I am writing to voice my concern regarding the Ashton Village Center Sector Plan to be presented on March 2, 2021. I support the positions sent in by the SSCA and SSARPC, but also felt the need to voice my individual opinion. While I have many concerns on what the future development in our area will bring, I will focus on three: building heights, design guidelines and the Implementation Advisory Committee.

Building Heights in the South East Quadrant of 108/650

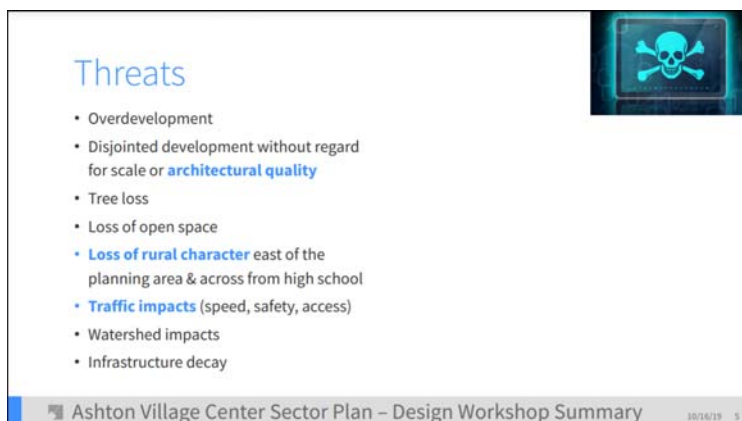
It is important to the community that we maintain a rural village character that embraces the heritage and uniqueness of Ashton. This came out as a key theme in the very well attended Design Workshop held by the Planning Staff in Oct 2019. Below is an output of that workshop, which highlighted overdevelopment and the loss of rural character just a few of the potential threats of the Ashton Village Center Sector Plan.¹

The SE Quadrant, where most of the proposed development is focused, is at the rural edge of 108 and the proposed zone for this area would allow for 45' high buildings. I believe it would be in the best interest of community stakeholders, and those that spend time in our area, to limit the zone in this area to heights of 40'. While 15' does not sound like a great difference, it would mean that we could see a large swath of four story buildings in Ashton, where no 4 story buildings exist today.
